## MEMORANDUM ADDENDUM #2

**TO:** All Bidders  
**FROM:** David Chen  
**DATE:** April 7, 2021  
**RE:** Reconstruction to the Dobbs Ferry Springhurst Elementary School and Middle/High

## **ADDENDUM NO. 2 dated April 7, 2021**

BID Addendum No. 2  
to  
Drawings and Project Manual

**PERFORMANCE LIGHTING-  
PERFORMANCE DIMMING &  
CONTROL BOX SCHEDULE**

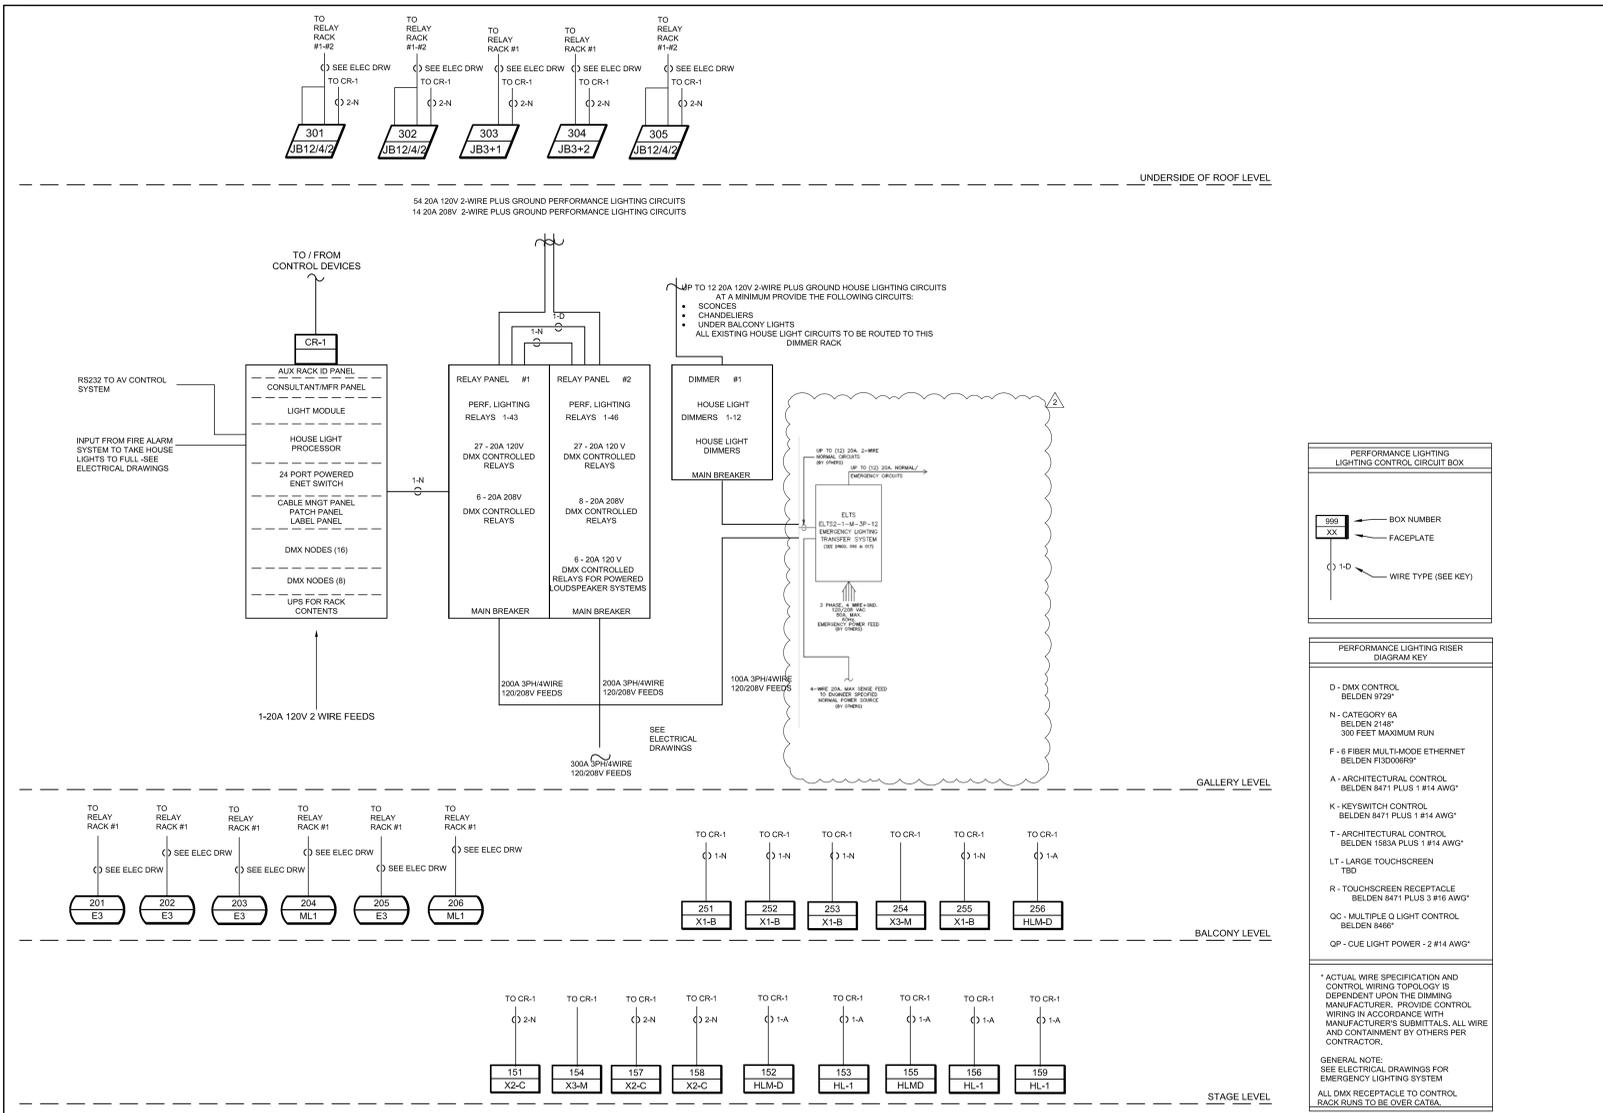
3. **QUESTION:** Reference Drawing Plate TL111: The Box Schedule has 154 + 254 as X2-L. The Control Riser has 154+254 as X3-M. Verify.

5. **QUESTION:** Reference TL111. Clarify the following requirements for 'DMX NODES (16) / DMX NODES (8)'. Are you requiring (24) RSN-DMX4-T or (6) RSN-DMX4-T each with four terminal DMX outputs?

7. **QUESTION:** TL111: Verify the devices JB are the ColorSource Raceway junction boxes or provide model number

8. **QUESTION:** Reference TL111: Is device 159/HL-1 required as new?

9. **QUESTION:** Reference TL111: Is device 256/HLM-D required as new?

10. **QUESTION:** Reference BE600 – RELAY RACK, HOUSELT RACK, RELAY RACK each receiving 100A three phase power in Panelboard AUD. Riser TL111 indicates Relay Panel #1 and #2 each receiving 200A power feeds. Please verify the power feeds required for these racks.

11. **QUESTION:** Reference TL111 Dimmer #1. Please provide rack model number, rack panel schedule, and dimmer module type assignments.

12. **QUESTION:** Reference TL111 states Emergency Power – See Electrical Drawings. No Emergency power requirements are located on the Electrical Drawings. Please confirm there are no emergency power or DMX signal management requirements for the TPC system.

**RESPONSE:** Use X3-M there is no X2-L faceplate on sheet TL131

**RESPONSE:** 24 DMX out/in configurable and universe addressable at the rack. See note above ENET on stage electrics should be DMX.

**RESPONSE:** Devices are not in Colorsource raceways. Colorsource Raceway requires separate power circuit for DMX active splitter which we do not have. Provide boxes as single gang DMX receptacles mounted to Colorsource Raceway.

**RESPONSE:** Yes

**RESPONSE:** Yes

**RESPONSE:** Each relay panel to be wired for 200A 3ph 208v infeed power as shown on the riser. There is a total of 300A 208v 3ph to feed both also shown on the riser. Either panel needs to be able to pull a full 200A load, but not both simultaneously. Simultaneously they can only pull 300A minus whatever the house light dimmer rack is pulling

**RESPONSE:** Dimmer #1 is envisioned as an ETC Drd or equivalent series rack with space for up to 12 dimmer modules for controlling the existing house lights circuits when fitted with new LED lamps. Type of module will depend on type of lamp chosen.

**RESPONSE:** The entire dimmer rack #1 should be assumed to be on emergency power for lighting and should be equipped and programmed upon loss of signal to take the fixtures to full. Provide ELTS if required.

Window Type W1 - BID ADDENDUM NO 2

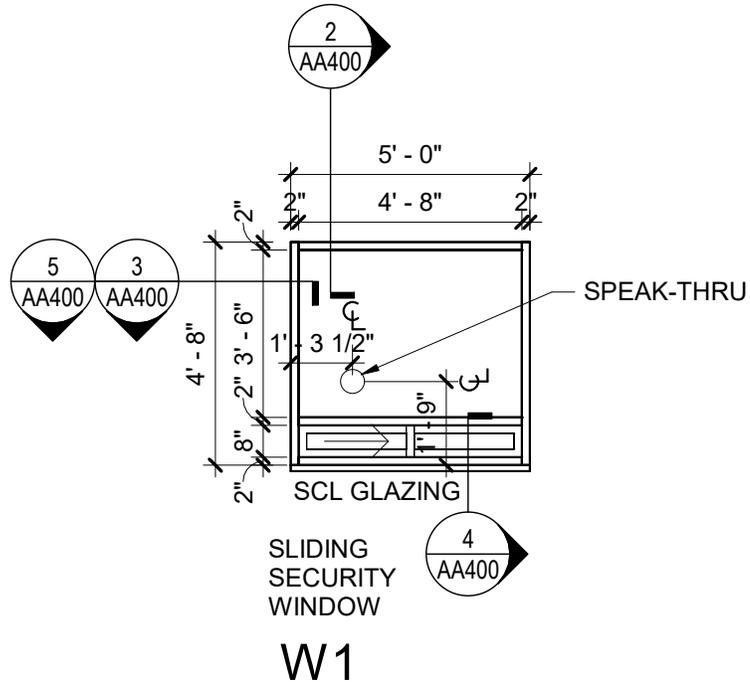
ITEM 2-C-9: Refer to DRAWING BA600

1. Glazing Type for Window Type W1, AMEND to read as follows:

THIS DRAWING PARTIALLY SUPERSEDES  
WINDOW TYPE W1 ON AA600

“FC GLAZING”

**BM02B**

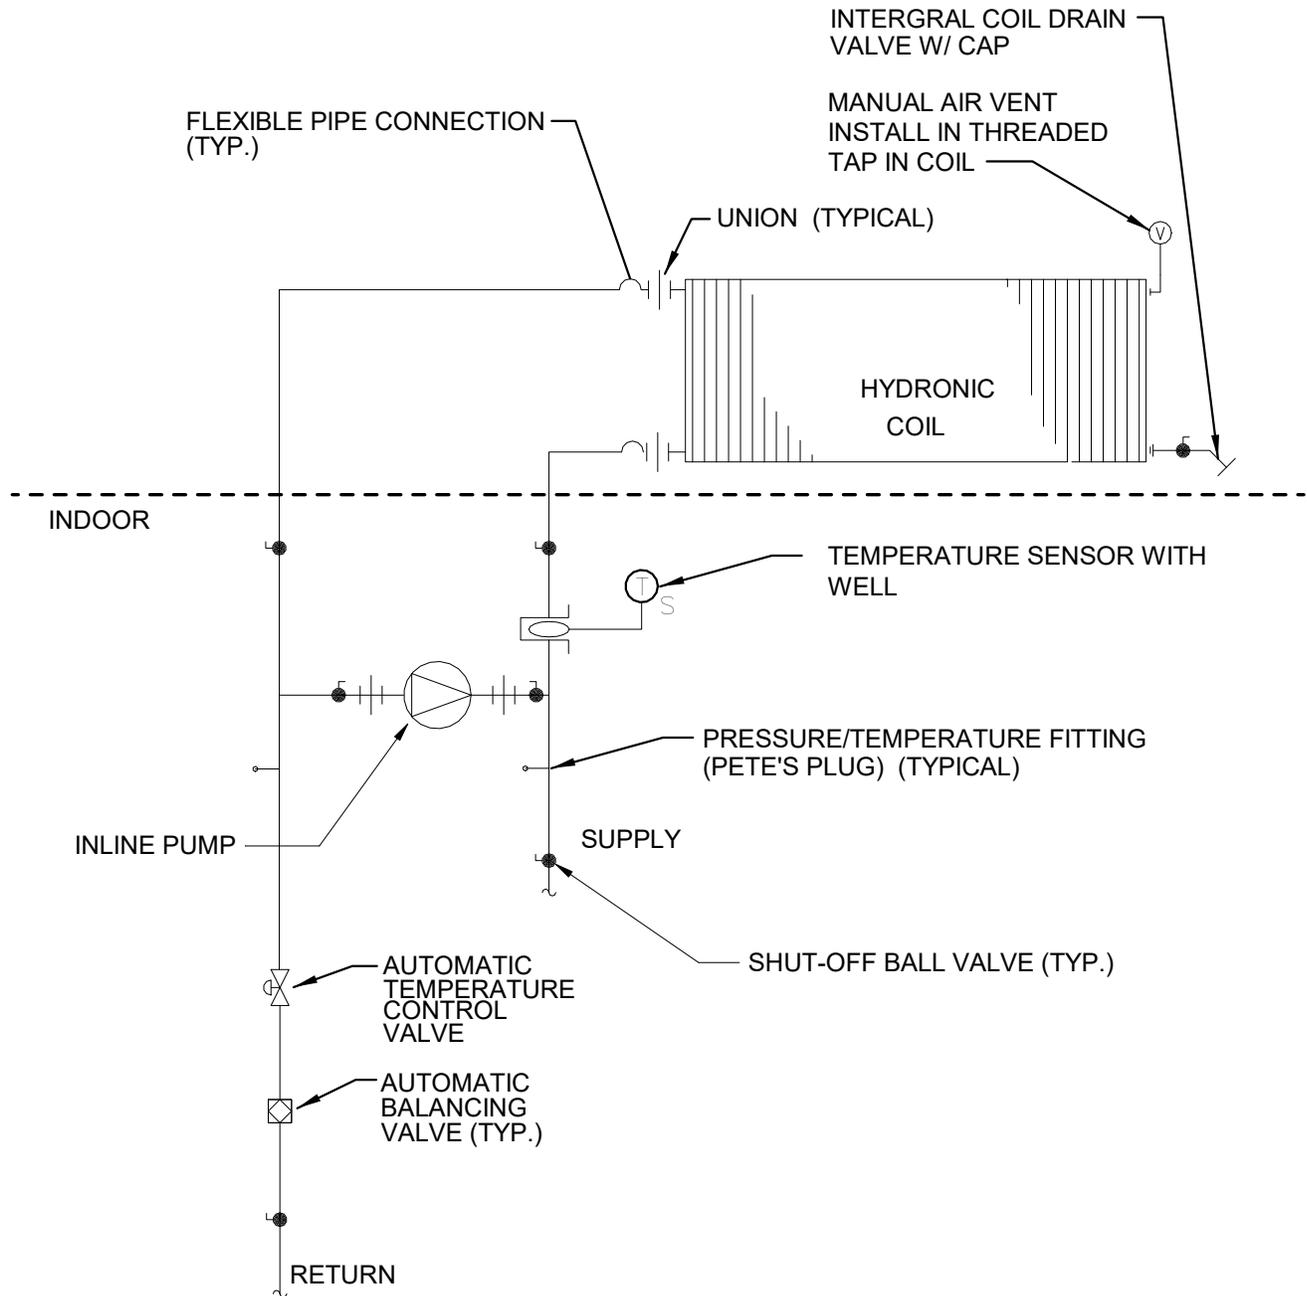
ITEM 2-C-13: Refer to DRAWING BM501

1. ADD Detail 1, Drawing BM02B attached to this addendum.

Proj. No.: 234903-20001  
Date: 03/29/21  
Drawn By: Author  
Drawing No.:  
**BM01B**

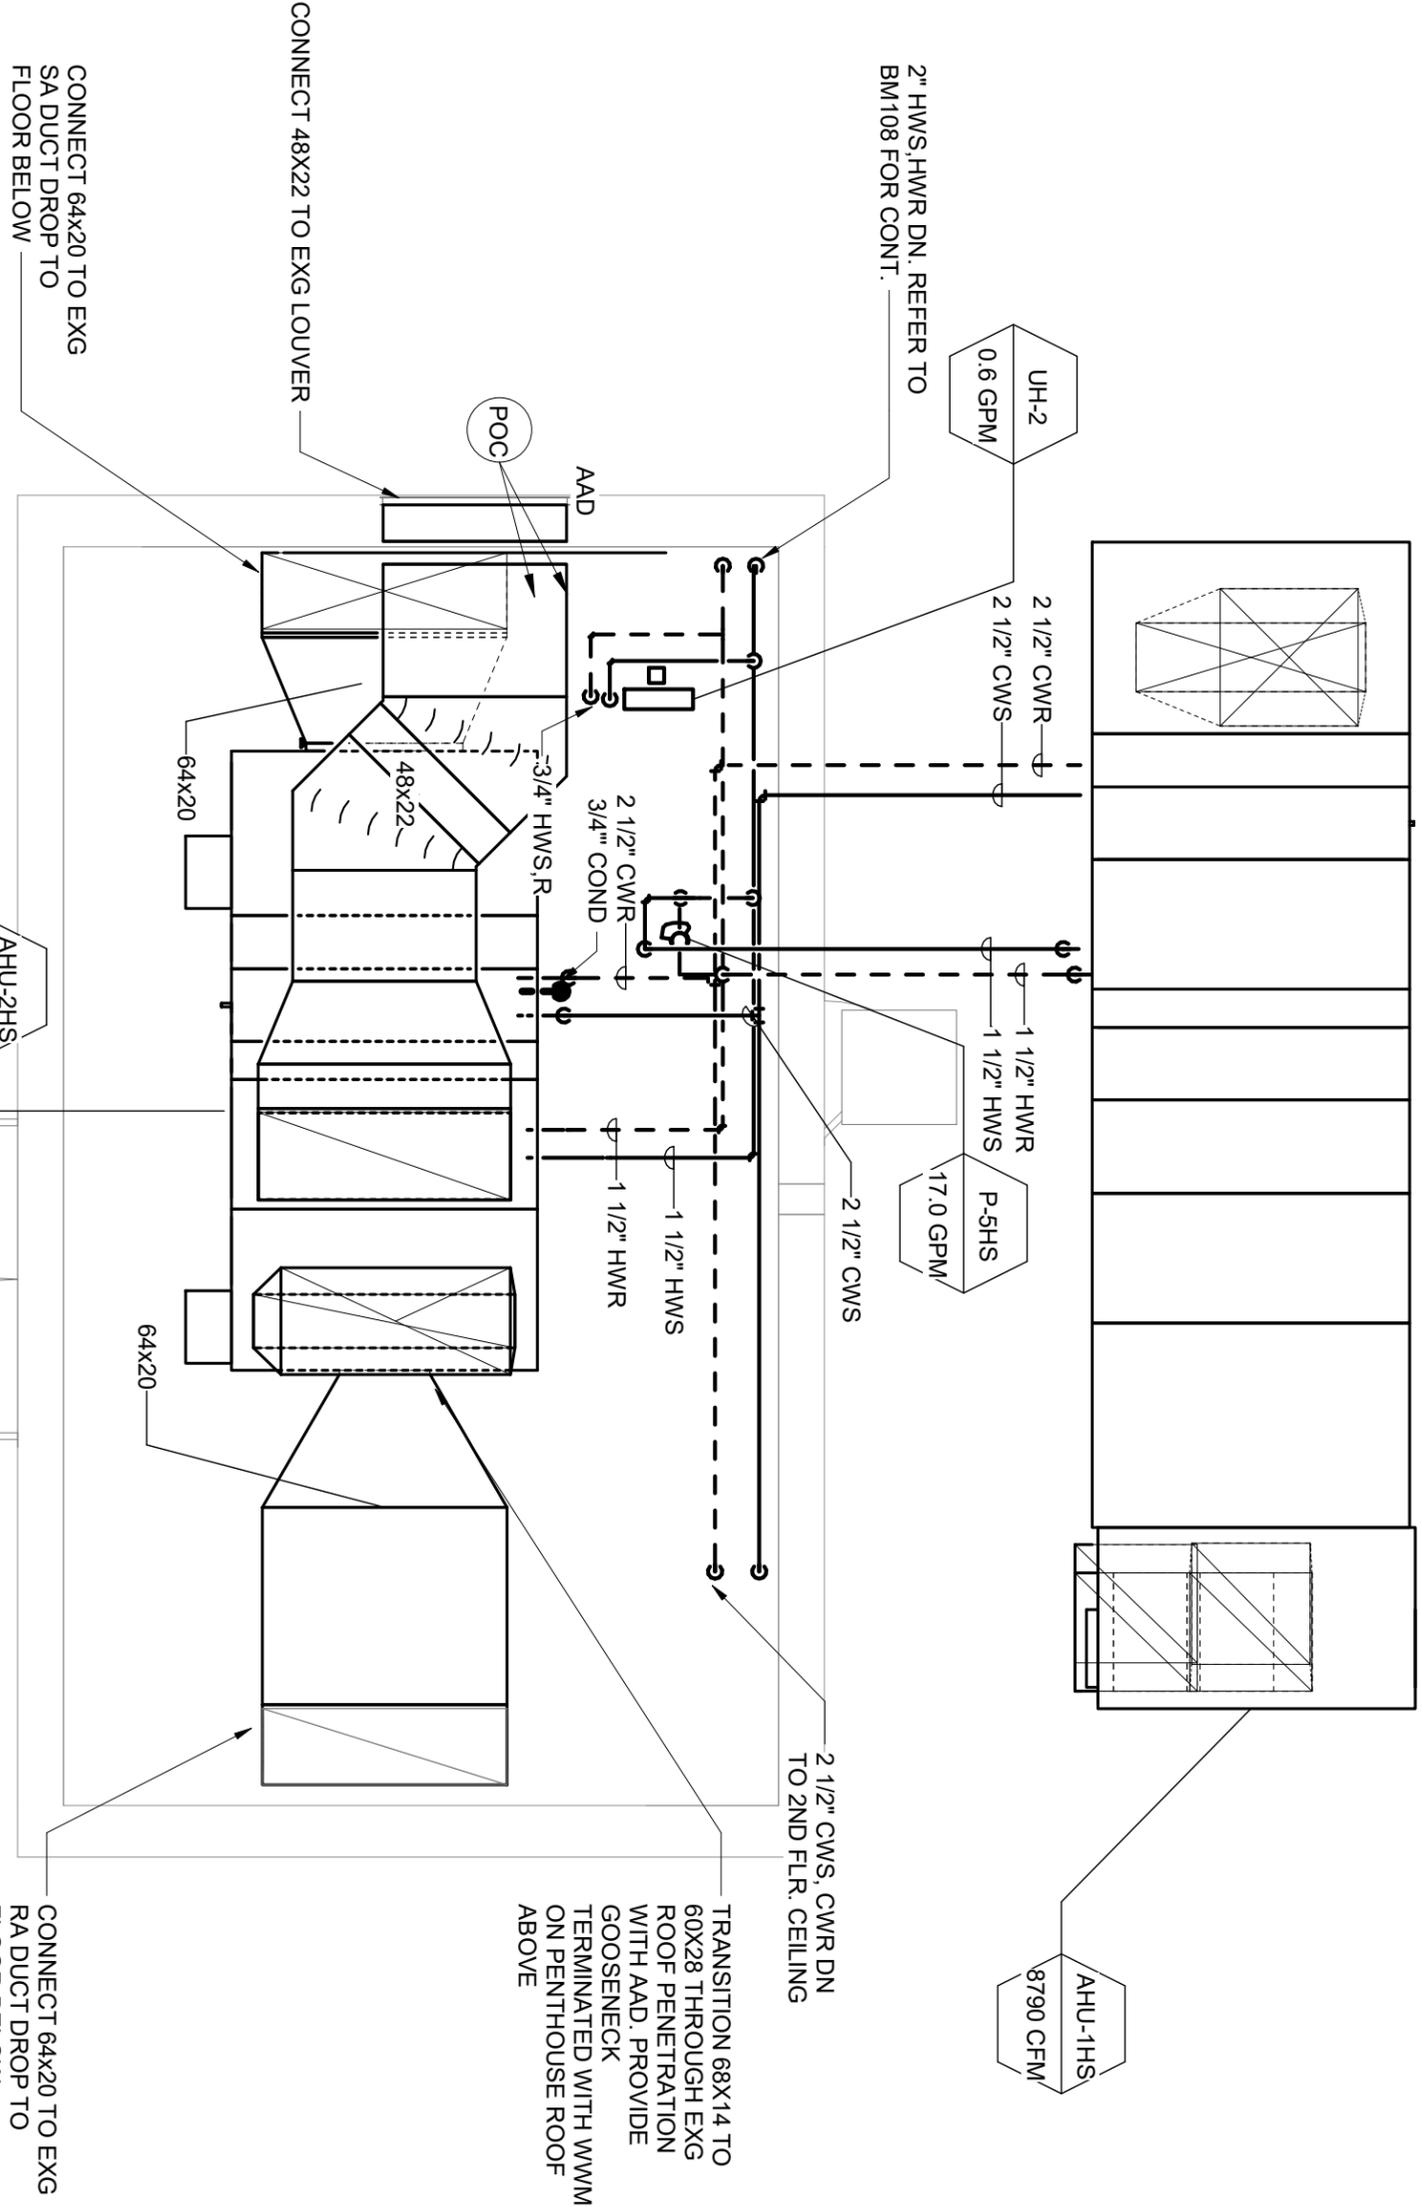
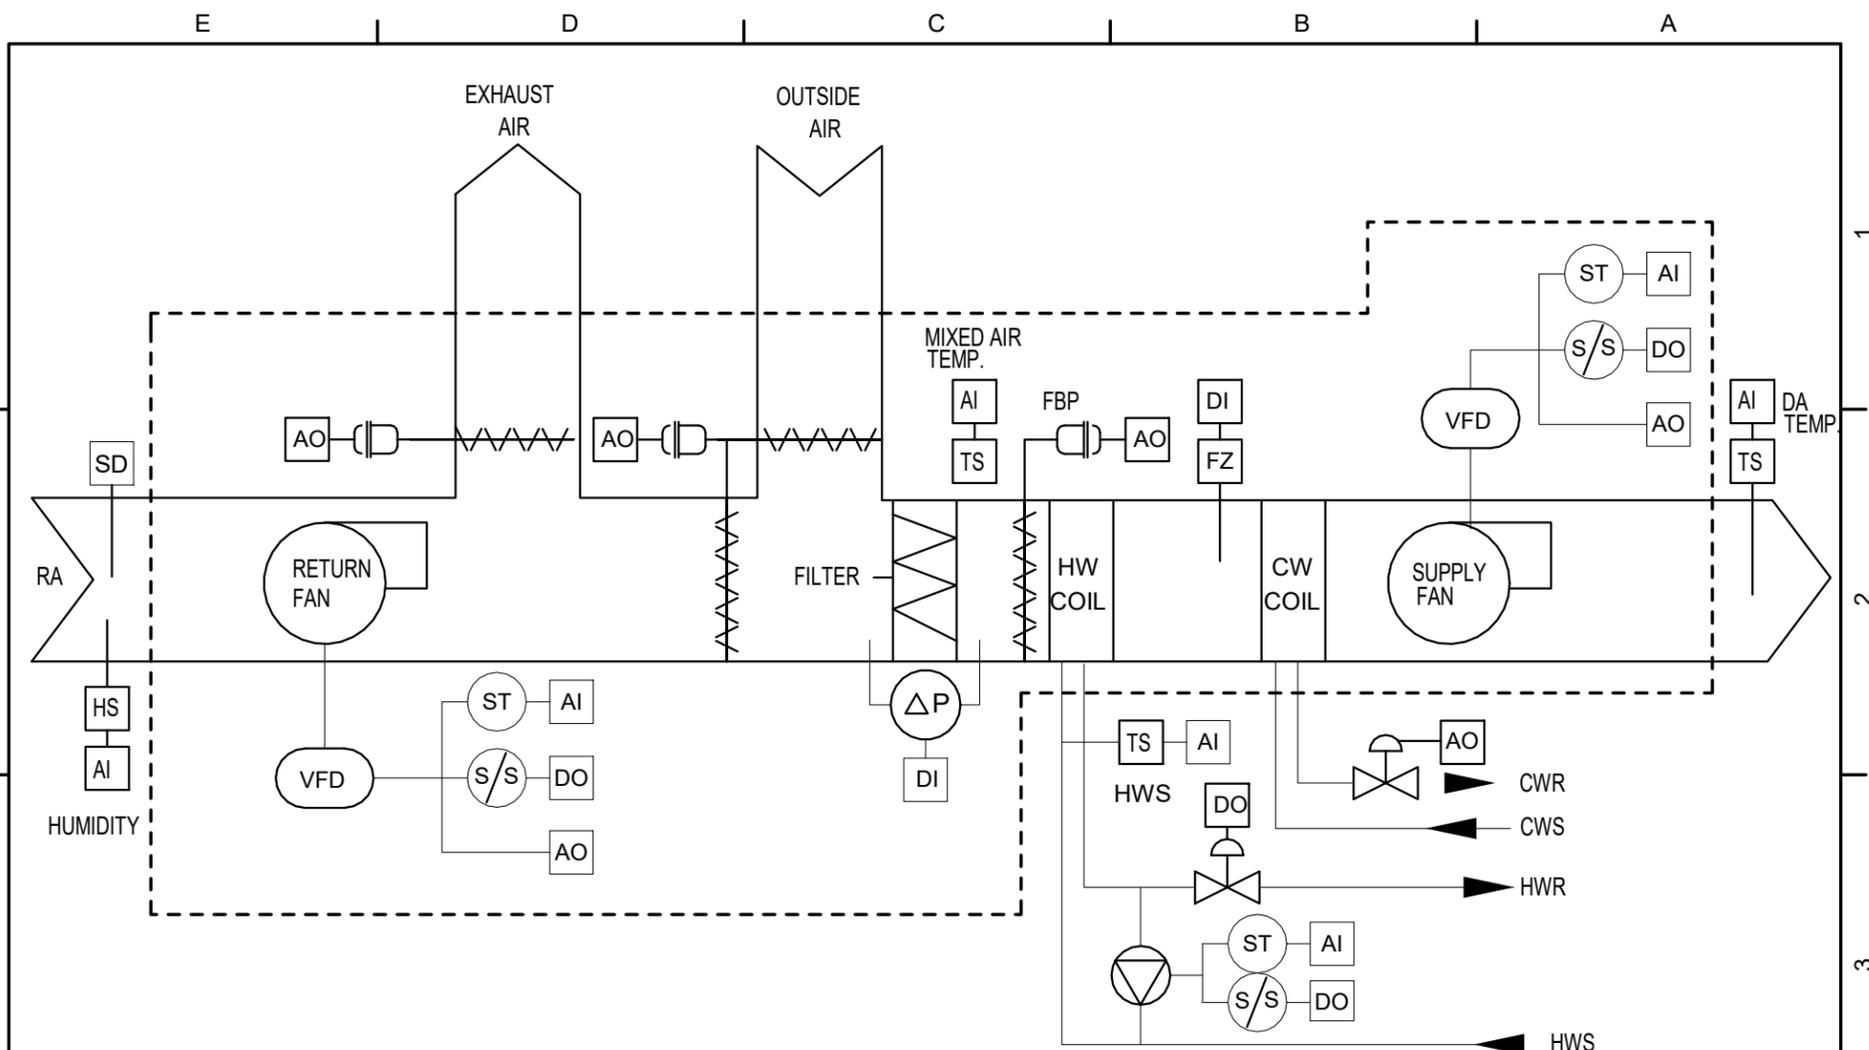
ITEM 2-C-12: Refer to DRAWING BM400

1. Detail 1/BM400, DELETE in its entirety and, ADD Drawing BM01B attached to this addendum.
